# BOARDS & COMMISSIONS APPLICATION

**Application Number** P23-18

**P23-18**  
**Sealy Mobile Office Building**

Property Owner: Carl and Connie Schoen  
Applicant: Carl Schoen  
Location: West side of Lake Road with parcel number 028-19C-22-019  
Zoning: I-1 (Industrial)  
Request: Site Plan approval for a modular office building

SHEET TITLE:  
**SITE PLAN**

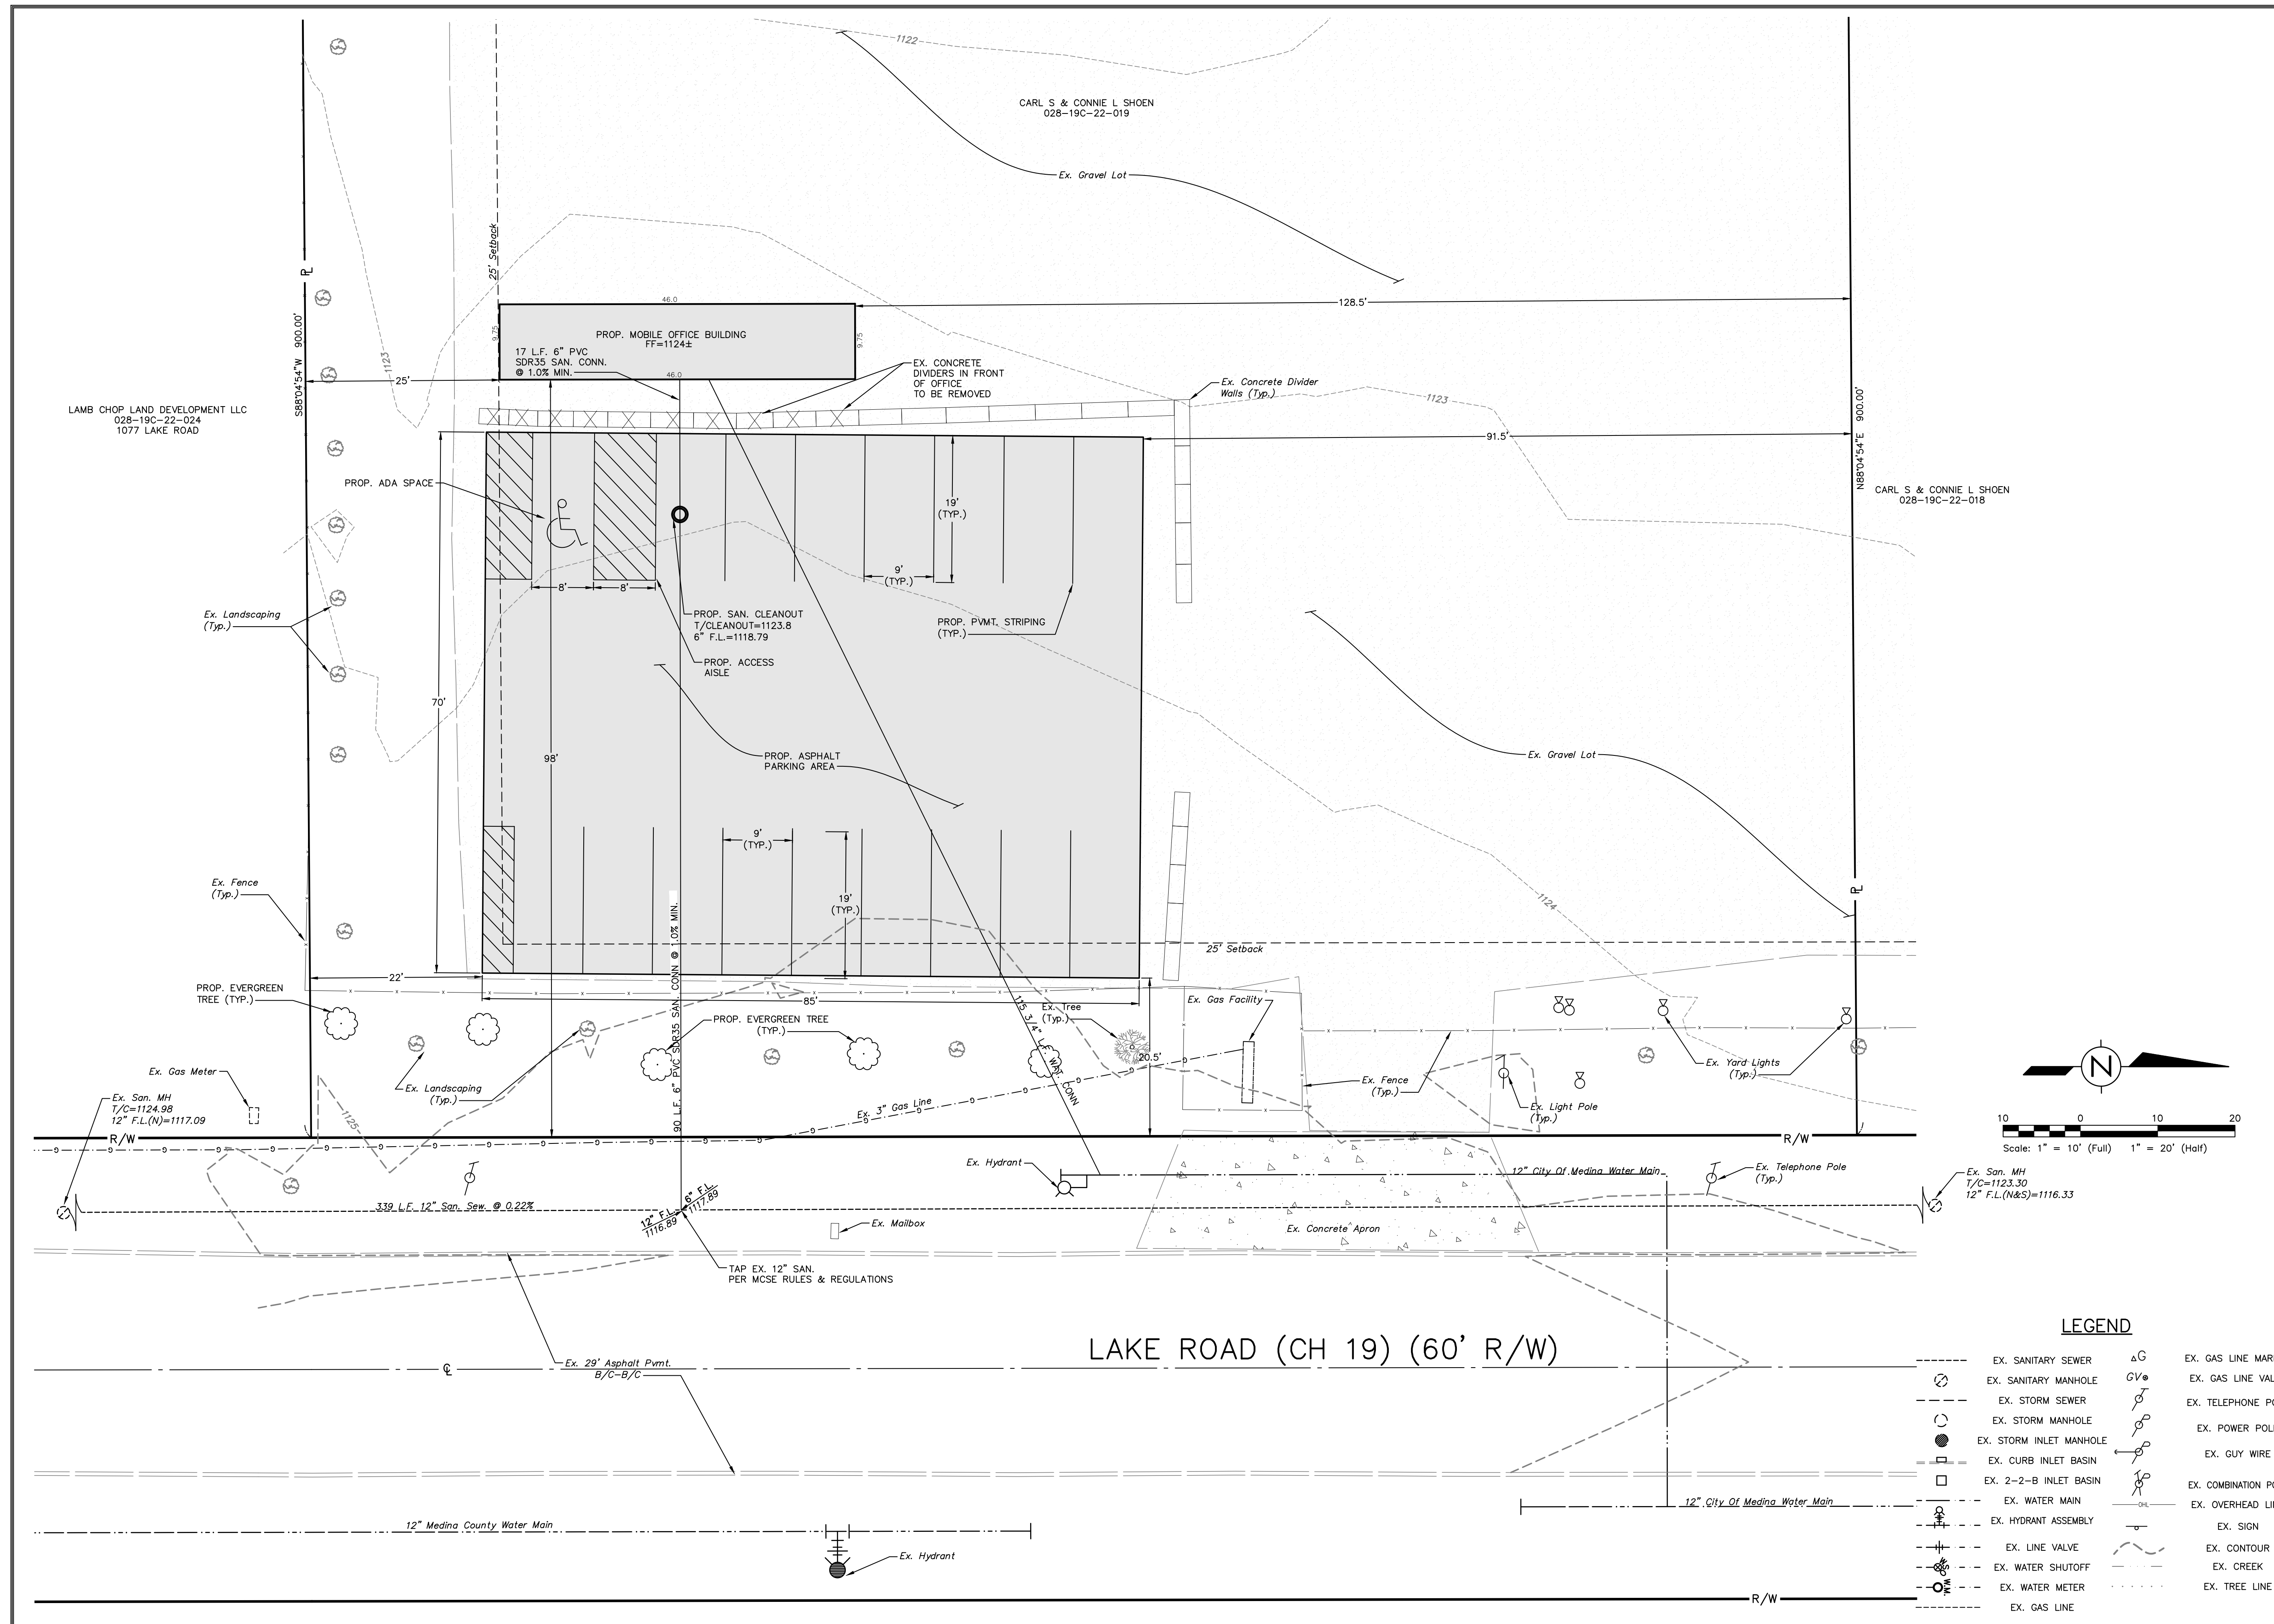
Access and Circulation – The site currently has an access point off of Lake Road, which is not utilized. Vehicular traffic will access the site from commonly owned property to the north, which connects to Lake Road.

Required Off-Street Spaces – Per Section 1145.04(e), office uses require a minimum of 1 parking space for every 200 sq. ft., which results in 3 required parking spaces. In order to prevent excessive lot coverage, the minimum number of parking spaces may be exceeded by 20%, “unless good cause can be shown by the applicant and approved by the Planning Commission”

The proposed site includes 20 parking spaces. However, though the proposed building is referred to as an “office” it appears to address a parking need for the larger site.

Parking Dimensions – Per Section 1145.08, ninety-degree parking spaces must be 9 ft. in width and 19 ft. in length with a 24 ft. wide drive aisle. Parking spaces meet the applicable standards.

Sidewalk – A public sidewalk is not proposed and a does not exist on Lake Road or in the area. The Planning Commission may waive the requirement to install a public sidewalk in the I-1 zoning district.

Parking Lot Landscaping – Landscape features or other visual barriers are required between parking and the right-of-way in industrial areas. Plans show existing landscaping between the proposed parking lot and the right-of-way. As the area is being converted to a formal parking area with a permanent building, additional landscaping has been provided.

Buffering and Screening – Landscape features or other visual barriers are required between the site and residentially zoned properties. A residence is located on the east side of Lake Road in Lafayette Township. Additional landscaping proposed between the parking lot and the right-of-way provides sufficient screening.

Staff recommends **approval** of application P23-18 as submitted.

FRONT ELEVATION

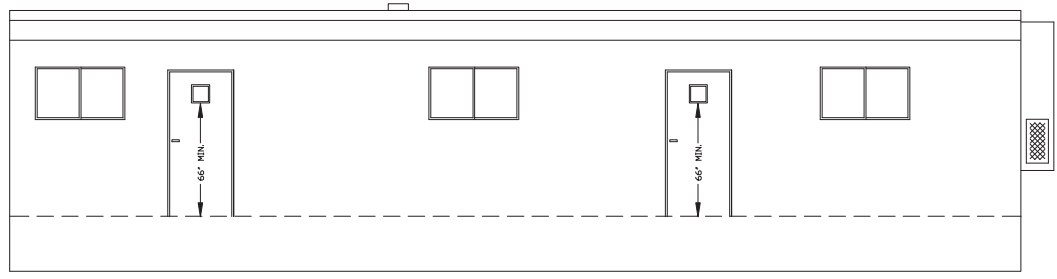
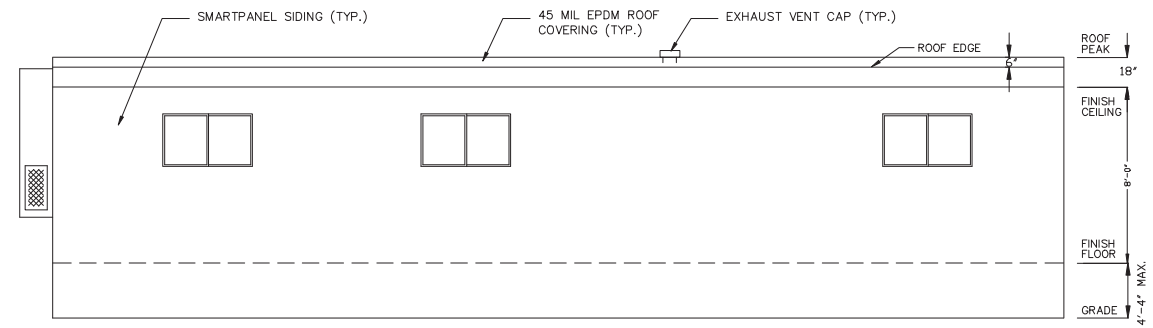
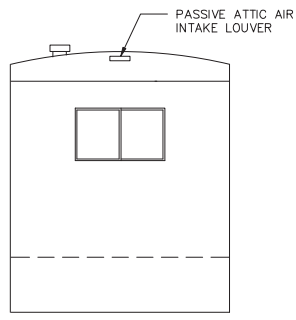
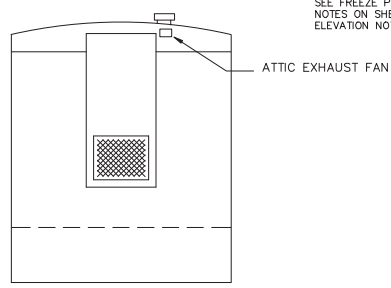
Architectural building elevations indicate a typical modular building with wood siding. The building is shown with skirting on the bottom portion and incorporates windows and doors facing Lake Road.

In the I-1 District: Architectural details and ornamentation on the street façade shall be meaningful to the overall design and appropriate for the size and scale of proposed structures, and harmonious with other architectural details and ornamentation on adjacent structures and All exterior finished materials, including windows and doors, shall be of architectural grade with long term maintenance characteristics.

Similar structures have been located in the I-1 District, though not in areas adjacent to roadways.

Lighting must comply with Section 1145.09(c) including a photometric plan, full cut-off fixtures, and a maximum lighting height of 25 ft. No parking lot lighting has been proposed and the building includes low-level (60 w) lights above the doorways.
